SITE PLAN REVIEW AND APPEARANCE BOARD STAFF REPORT

Milfred Industrial

Meeting	File No.	Application Type
January 22, 2025	2023-206-SPF-SPR-CL5	Level 2 Site Plan with parking reduction
Property Owner	Authorized Agent	
1215 Milfred Street, LLC	Kristen Nowicki, AICP

Consideration of a Level 2 Site Plan to construct a 5,597 square foot warehouse and office building associated with Architectural Elevations, and Landscape Plan and a parking reduction request.

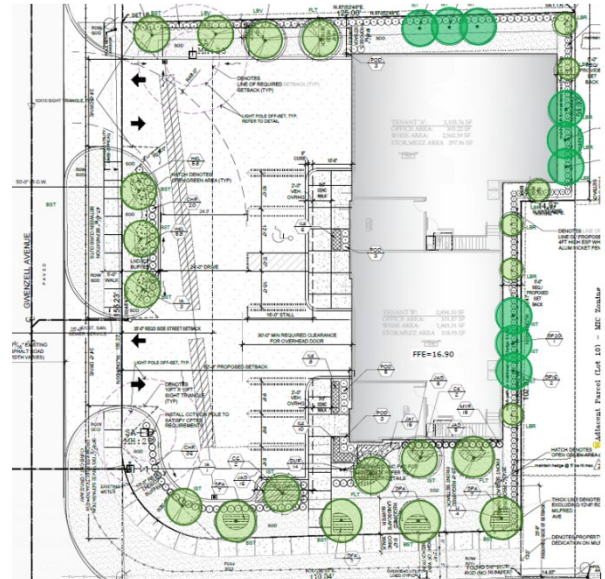
The Parking Reduction request is subject to a special documentation prepared by a professional traffic engineer concluding an analysis that justifies the reduction in number of required parking spaces can be accommodated on-site for said specific use. A Parking Reduction statement prepared by a traffic engineer is attached providing a parking calculation and justification. The engineer justifies the proposed warehouse and office use requires a total of 4 parking spaces based on the ITE Parking Generation Manual. The statement proposes that the 6 parking spaces on-site will meet the parking demand for the proposed use.

WEST ELEVATION

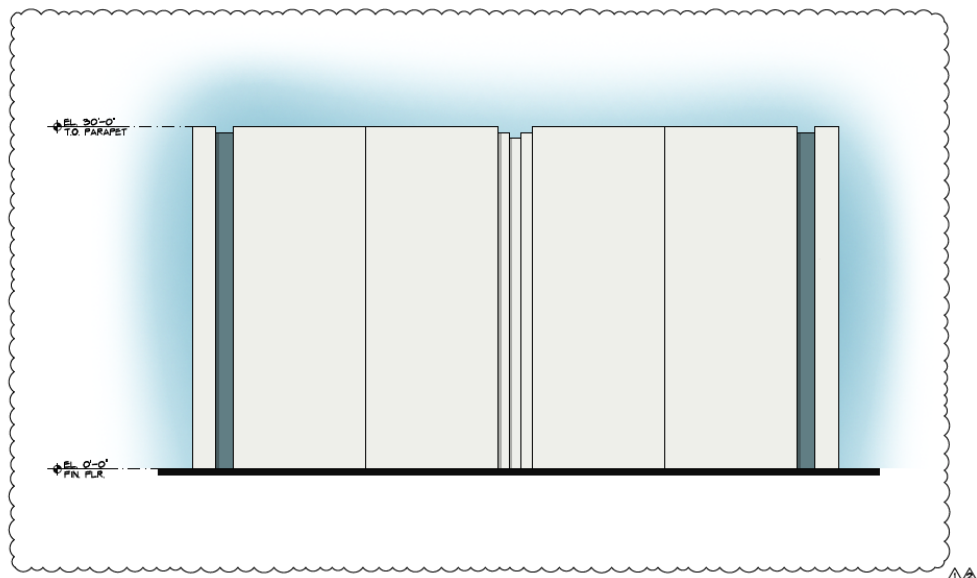
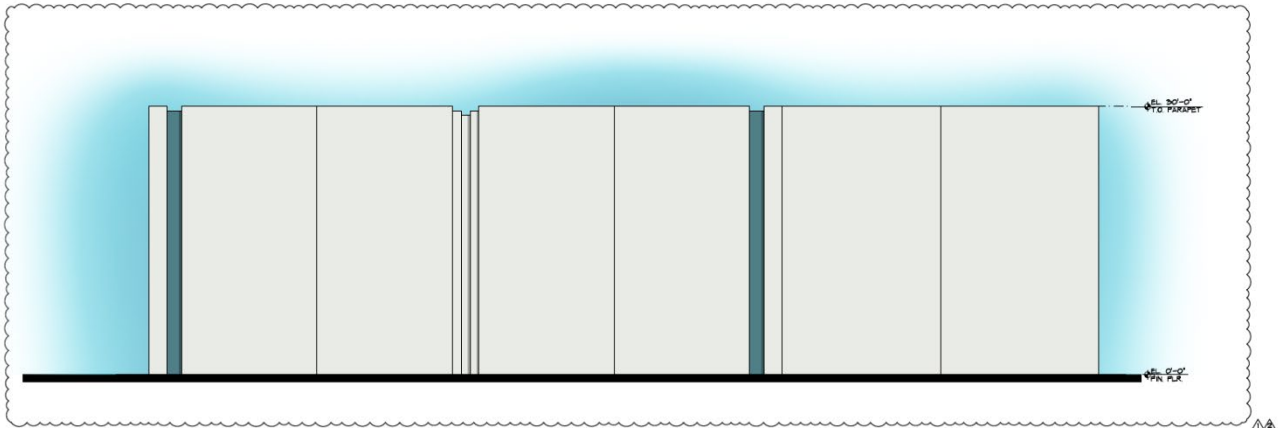
The design integrates with the surrounding typical warehouse style and with surrounding area. The use of materials such as recessed concrete panels and colors of dark navy, blues and white combined with horizontal overhangs and glass window to add visual stimulation on the west elevation facing Gwenzell Avenue and south elevation. The vertical 3/4" recessed concrete with Refuge Blue color on the north and east elevation and the lush landscape perimeter adds interest and softens the elevation from neighboring property to the east. The screening of the mechanical equipment on the roof top is properly designed to be integrated with the design of the building. Overall design strives to achieve visual harmony and express honest design construction.
